ELECTRONIC VALVE SPECIFICATIONS

SPECIFICATION CV 7311-20
ISSUE 1 DATED MARCH 20th 1962
AMENDMENT No.1

April 1963

Ministry of Aviation/SRDE

FIG. 3 DERATING CURVE.

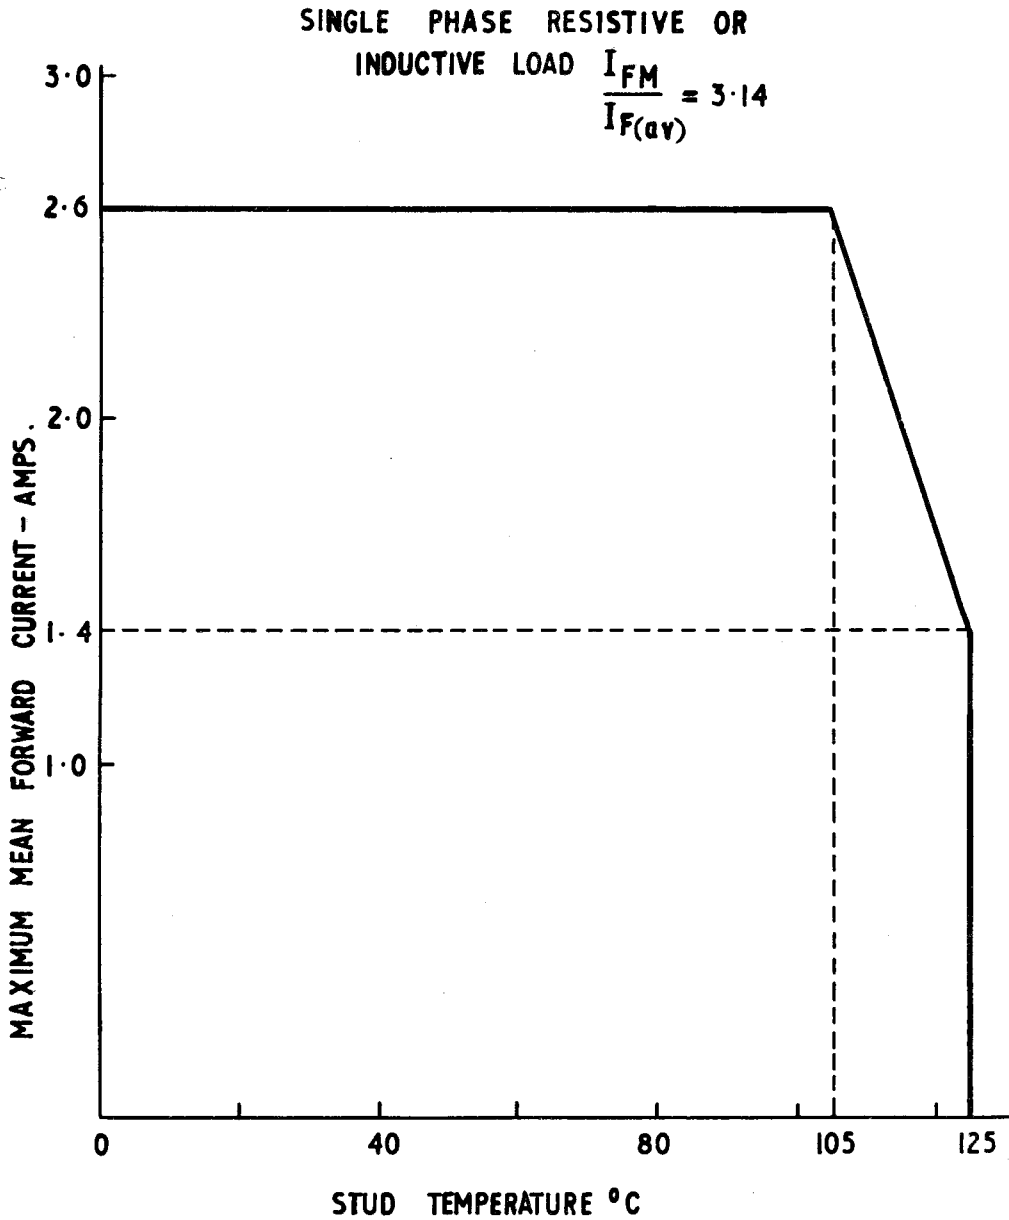
Amend Note D to read:

See derating curve Fig.3, Page 3.

Group F, Life.

Delete: T_{stud} not than 2.6 amps.

Insert: T_{stud} between 100°C . and 125°C . Forward current not than the value corresponding to the chosen T_{stud} according to the derating curve Fig.3, Page 3.
